Re: Amendment Request to Process an Alternate Feed Material from W.R. Grace at the
White Mesa Uranium Mill
Source Material License SUA-1358

International Uranium (USA) Corporation ("IUSA") hereby submits supplemental information in response to questions and comments received from discussions with Mr. von Till of the NRC staff during the week of April 17, 2000 regarding the above-named request for amendment to Source Material License SUA-1358.

Tailings Capacity Evaluation

White Mesa Uranium Mill
Blanding, Utah

SECTION A-A'
(See Figure III-I)

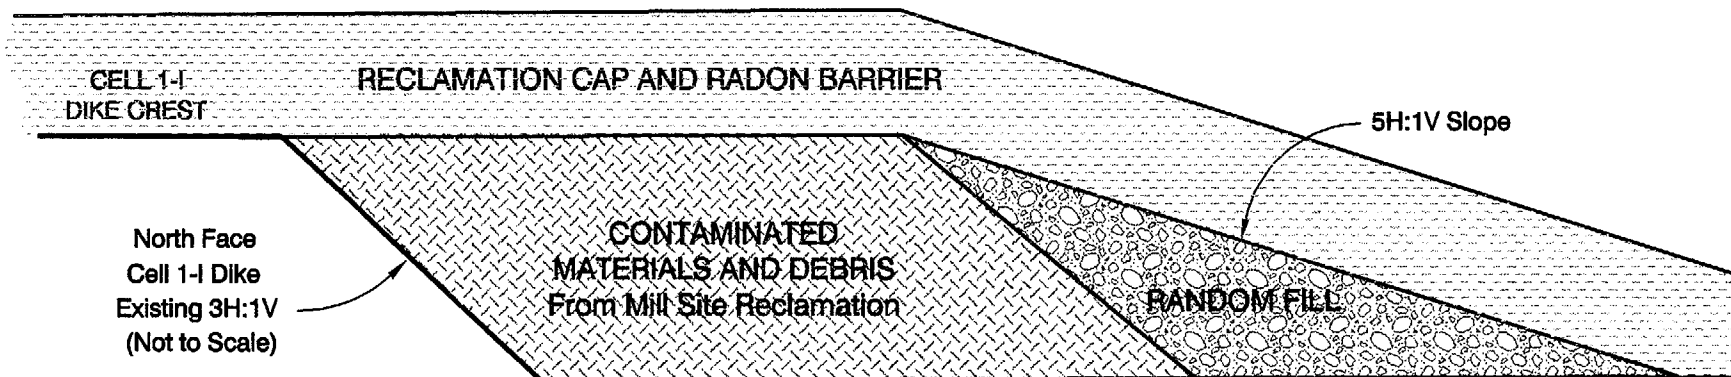
NRC requested that IUSA clarify that sufficient capacity is available in the existing tailings management system for the disposal of the tailings from the W.R. Grace material and the other approved and pending materials, plus the estimated quantity from the eventual reclamation of the tailings system and the mill site.

The second alternative is to modify the Reclamation Plan to allow for placement of approximately 280,000 yd³ of material from the Mill site cleanup, along the north slope of the Cell 2 dike, within a portion of the current Cell 1-I. The current Reclamation Plan specifies that all of the contaminated materials from Cell 1-I are to be removed from the cell upon final site reclamation, and the impoundment is to act as a sedimentation basin with an outlet to the canyon on the west side of the site. A scenario, which does not deviate from the general concepts of the existing Reclamation Plan, is to use a portion of the existing Cell 1-I excavation to store low moisture content material from the mill site, windblown areas and the mill debris, upon final decommissioning of the site

The remaining contaminated materials and debris from the Mill area reclamation would be placed along the upstream face of the dike between Cell 1-I and Cell 2, extending along the entire length of the dike. See Figure IV-1. The estimated volume of this material, 280,000 yd³, would cover an area approximately 160 feet wide along the 2,400 foot length of the dike. The total additional area would be approximately 9 acres. The width of the additional contaminated material would vary depending on the final volume of cleanup materials, and the concept would give the added advantage of having additional storage, if needed, in the remaining area of the Cell. The tailings area cap, including random fill, clay cap and rock armour would extend from the Cell 2 area as a continuous layer over the additional material. While the material placed in the Cell 1-I area will not have a bottom liner, the fact that the material is placed relatively dry (estimated to be less than 10% moisture content) and quickly covered with an engineered cap, will prevent any natural precipitation from moving through the material. This will eliminate the potential for migration of contaminants from this area. The current reclamation plan specifies that the Cell 1-I impoundment area is to act as a sedimentation basin with an outfall to the canyon on the west side of the site. This concept will still be preserved with approximately 80% of the Cell 1-I area still available for the sedimentation basin. The final location of the outfall channel will be adjusted based on the volume and area of material stored in Cell 1-I.
